**SUSQUEHANNA STEAM ELECTRIC STATION
PROPOSED LICENSE AMENDMENT NO. 285 FOR
UNIT 1 OPERATING LICENSE NO. NPF-14 AND
PROPOSED LICENSE AMENDMENT NO. 253 FOR
UNIT 2 OPERATING LICENSE NO. NPF-22 EXTENDED
POWER UPRATE APPLICATION RE: REACTOR SYSTEMS
TECHNICAL REVIEW REQUEST FOR ADDITIONAL
INFORMATION RESPONSES
PLA-6250**

**Docket Nos. 50-387
and 50-388**

Attachment 2 to PLA-6250
Non-Proprietary Version of the Request for
Additional Information Responses

Request for clarification/supplemental information in response to PLA-6209.

Figure A.16 0.05 ft² PD SF-BATT TOP 108F
Upper Downcomer Mixture Level

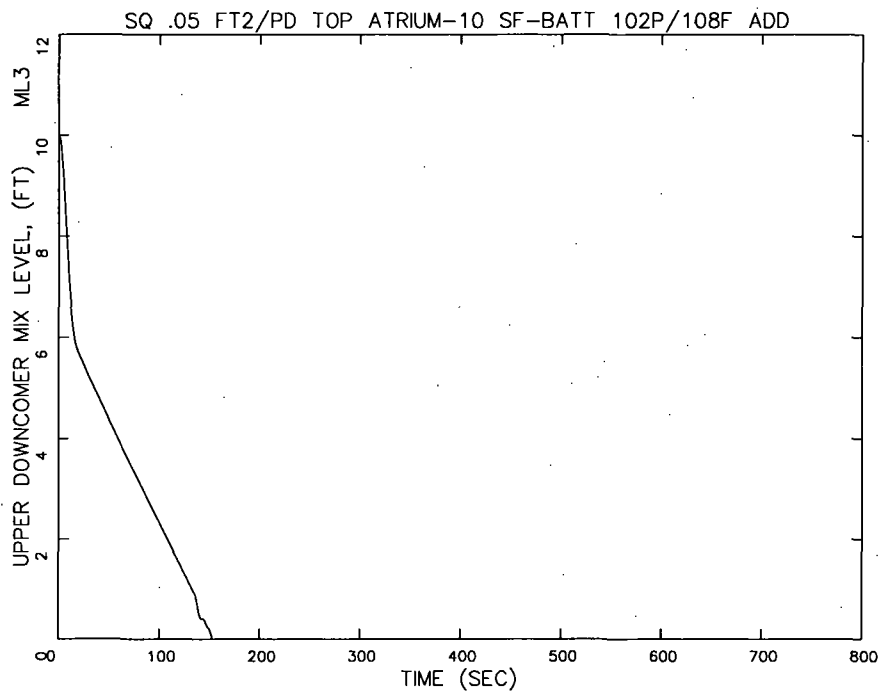
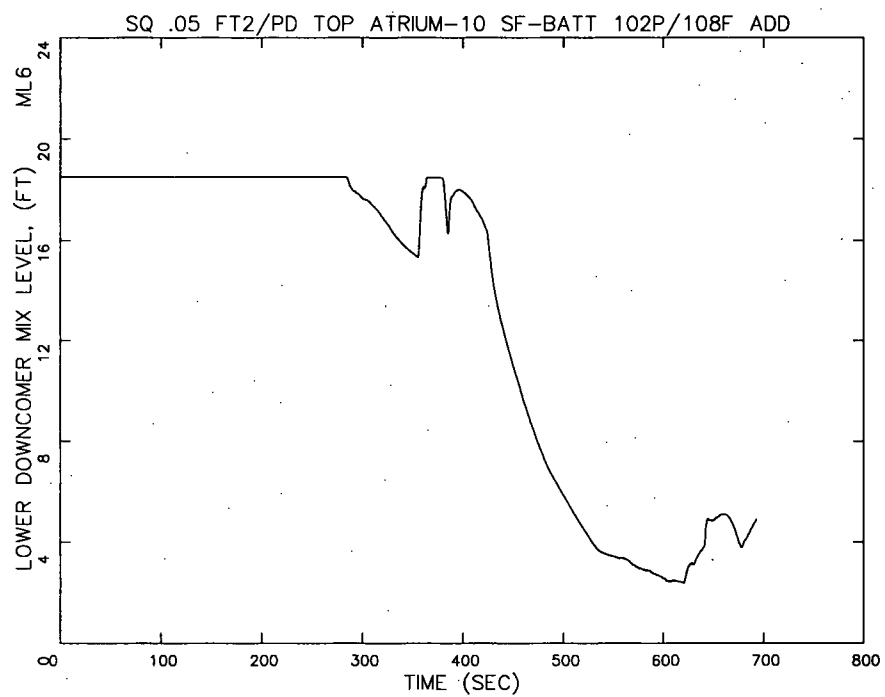
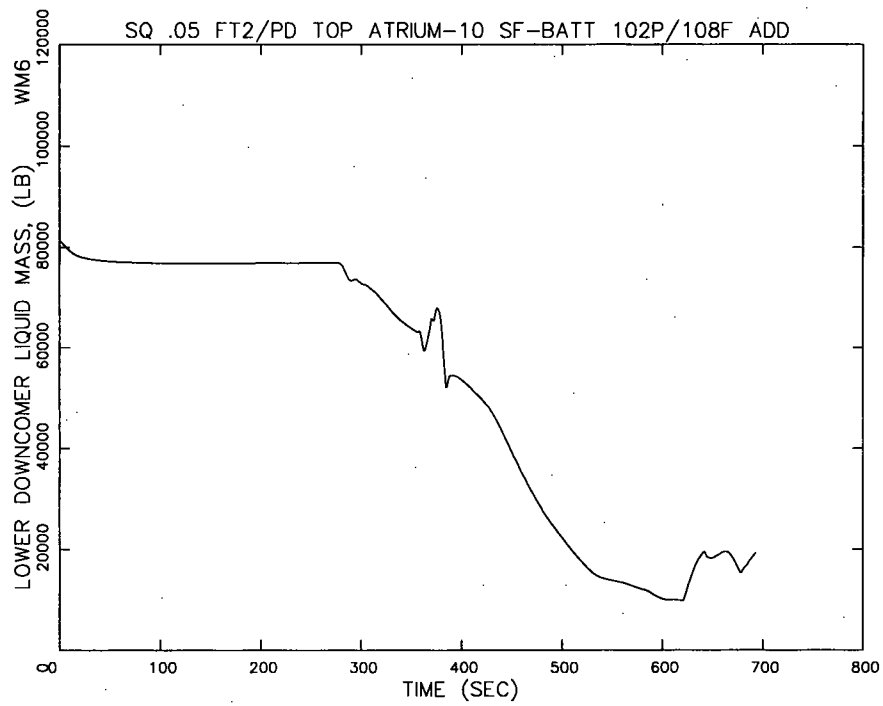
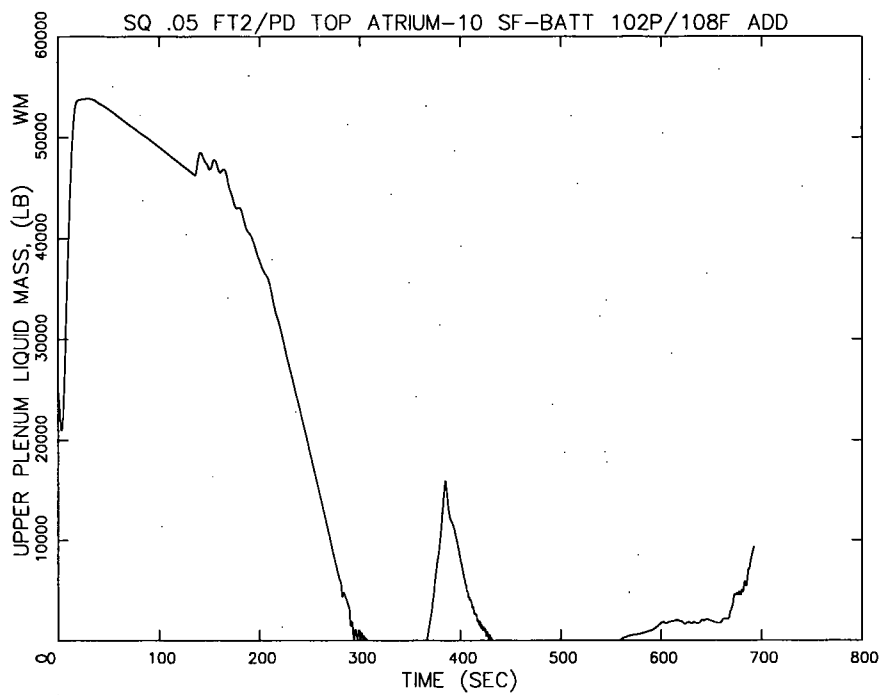
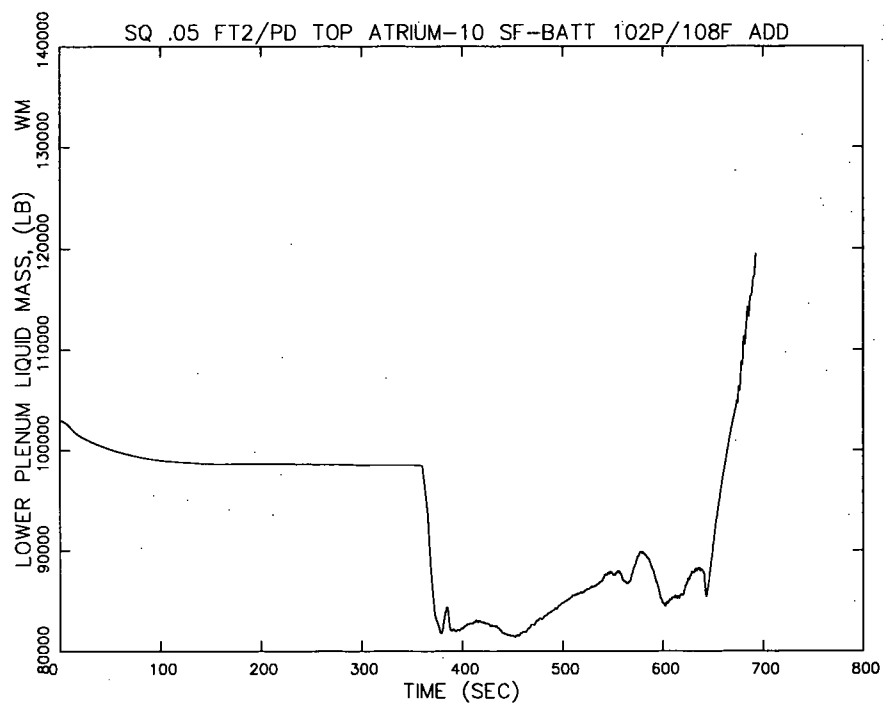
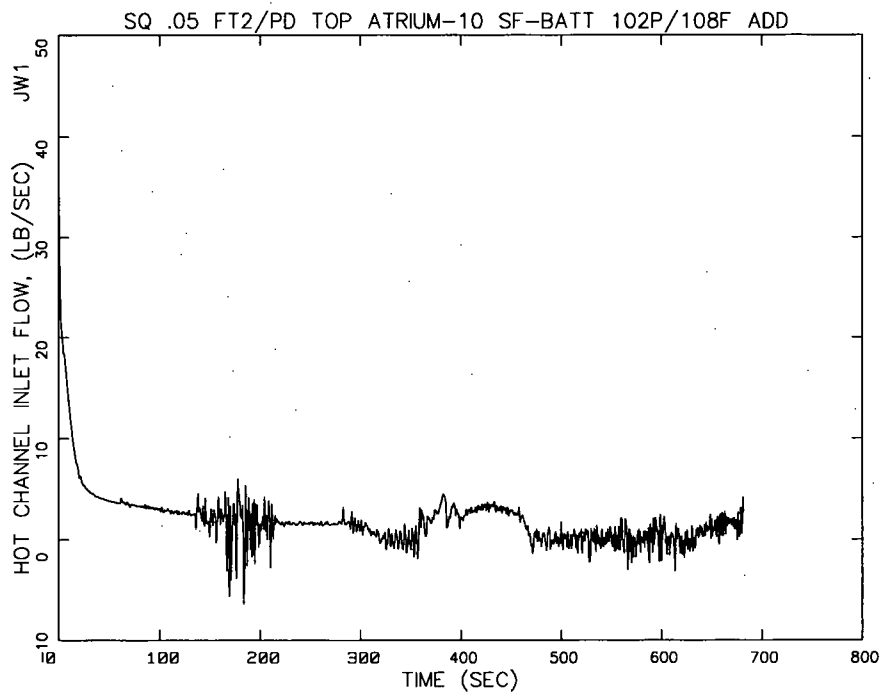
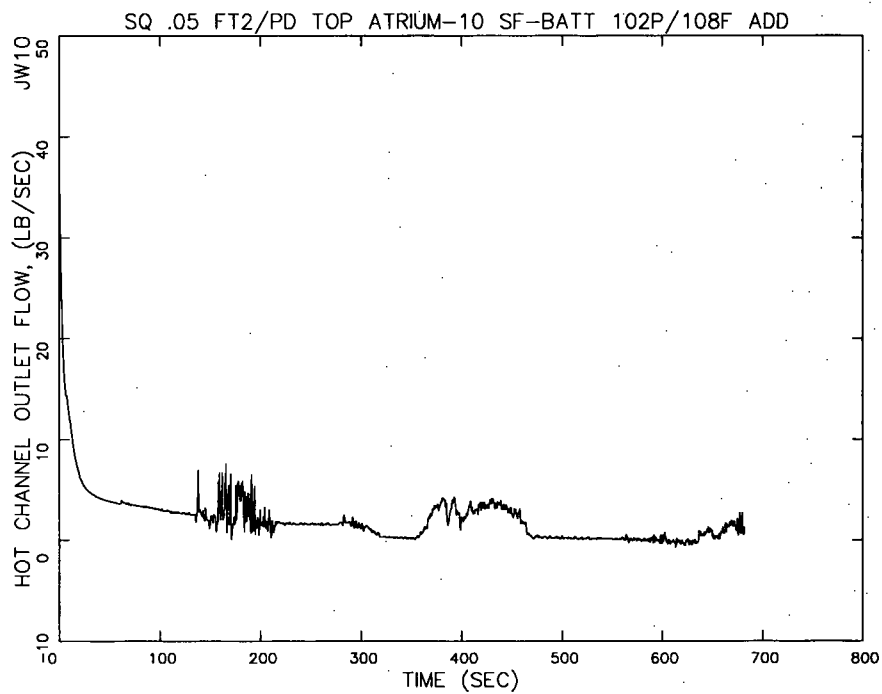
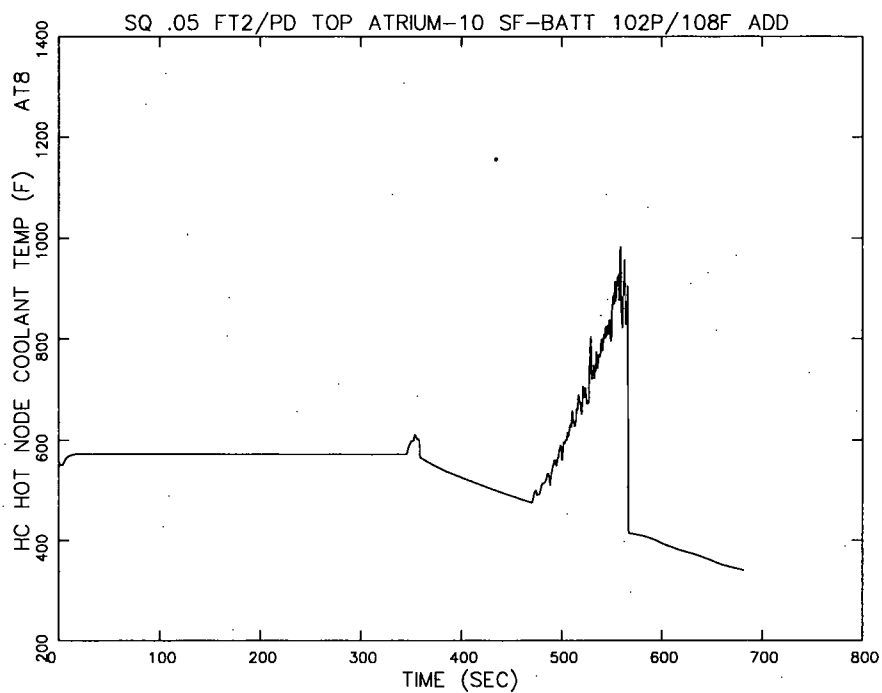
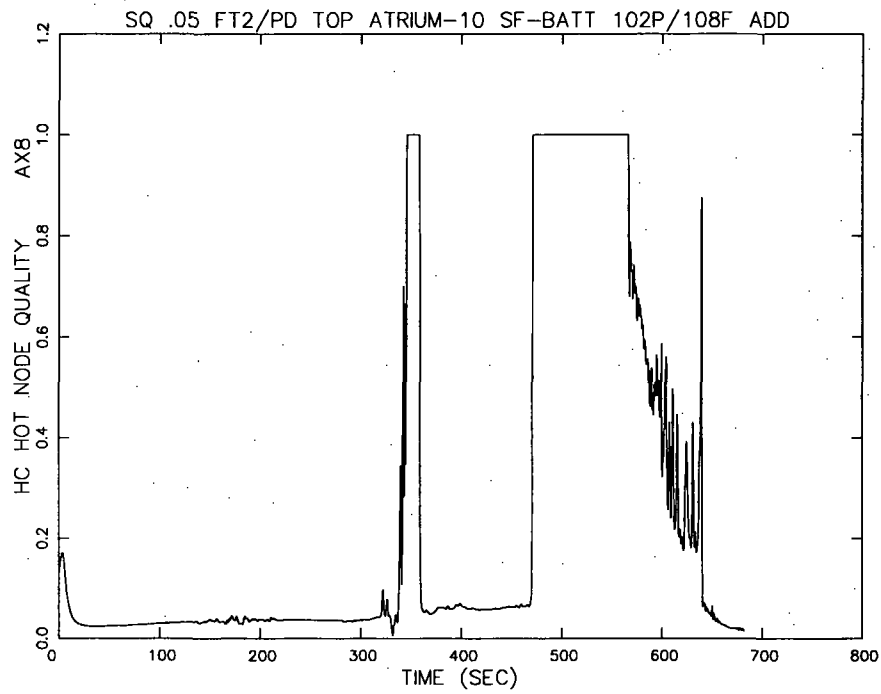
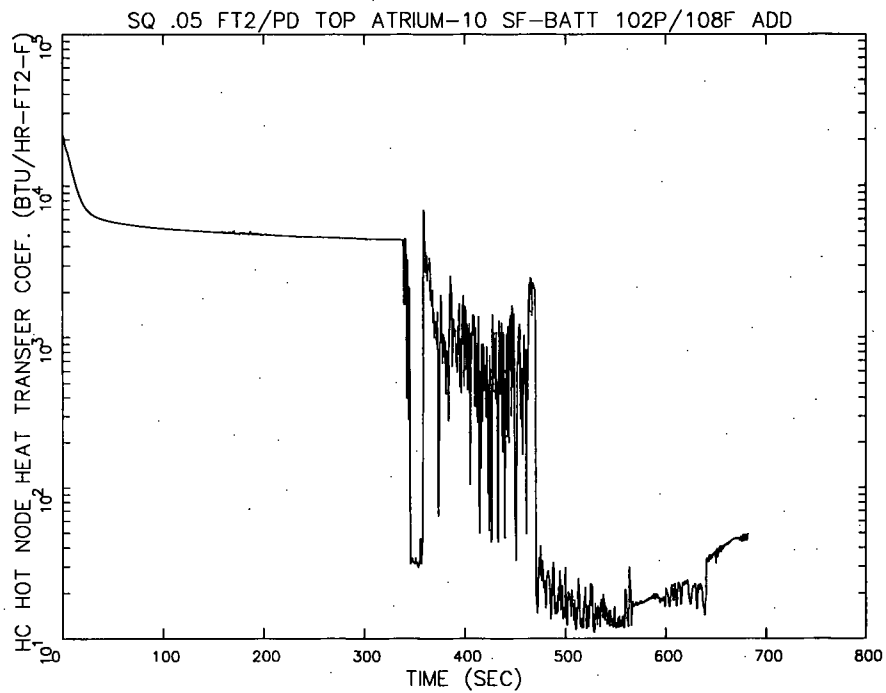
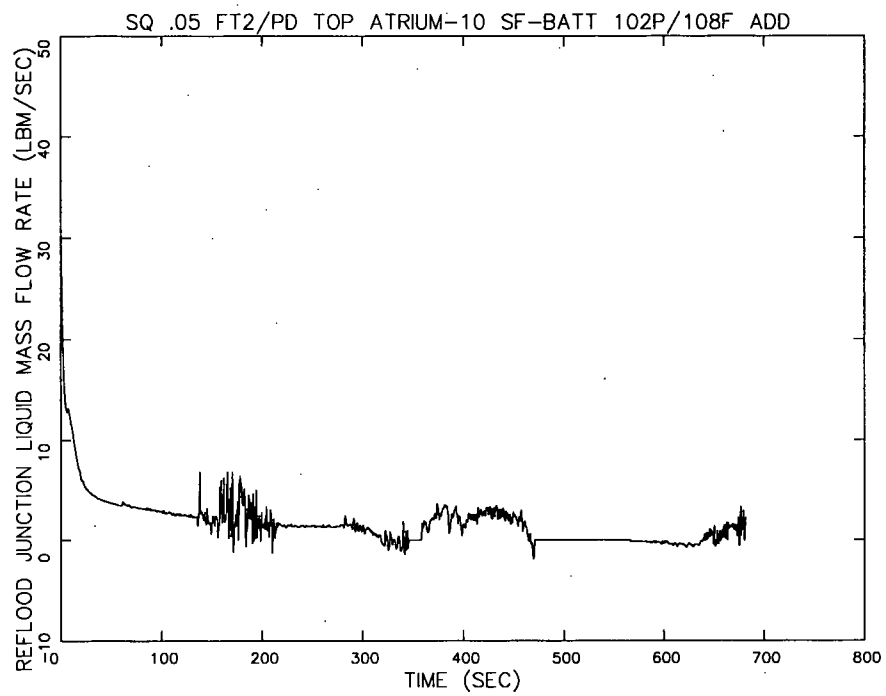
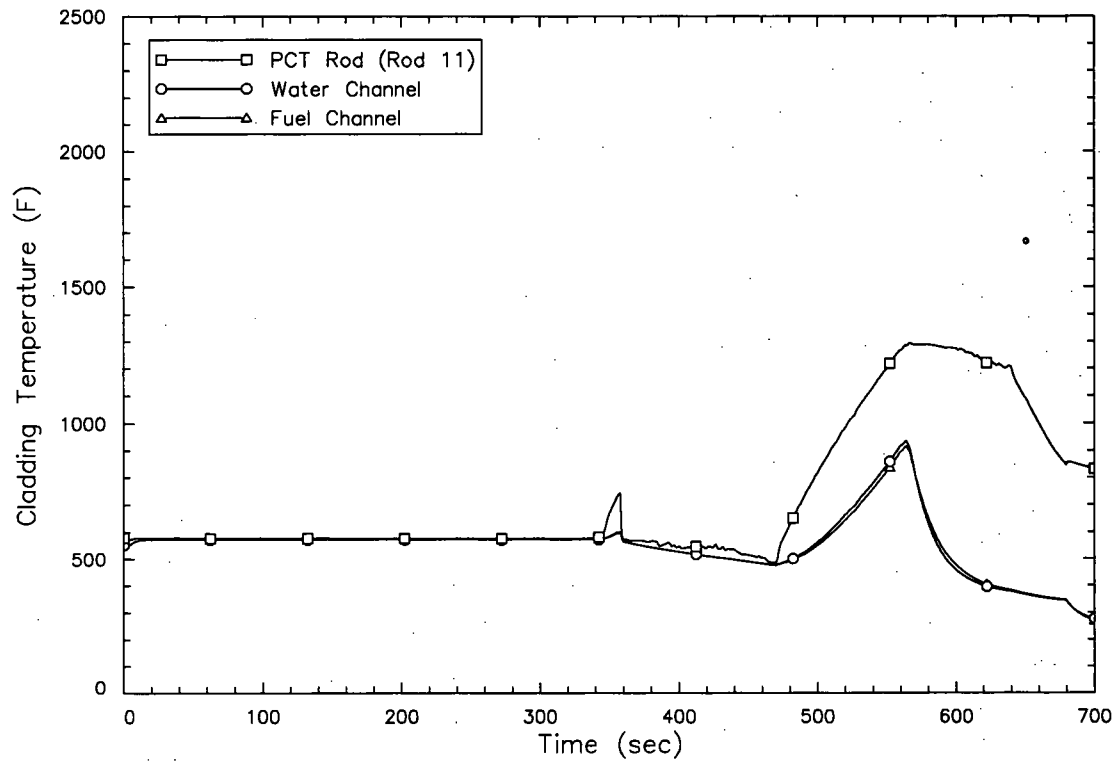
The staff performed a small break LOCA with break size less than 0.1 ft² at recirculation pump discharge side. The break characteristics include initial core flow of 108 Mlbm/hr, 102% power, top-peaked axial power profile and SF-BATT. The staff found the PCT in this break size range (less than 0.1 ft²) is much more limiting compared to break size at 0.7 ft² case. Please provide small break LOCA analysis result at break size of 0.05 ft² with same break characteristics. Please include major parameter plots as shown in the LOCA report (EMF-3242P, Revision 0) for TLO large break LOCA.

AREVA performed the requested small break calculation for 0.05 ft², initial core flow of 108 Mlbm/hr, 102% power, top-peaked axial power profile and SF-BATT. The PCT for this small break was calculated to be 1296°F, which is lower than the limiting large break PCT and lower than the limiting small break PCT calculated with AREVA methods. The sequence of events for the requested small break calculation is provided in Table A.1 followed by a set of major parameter plots similar to the LOCA report.
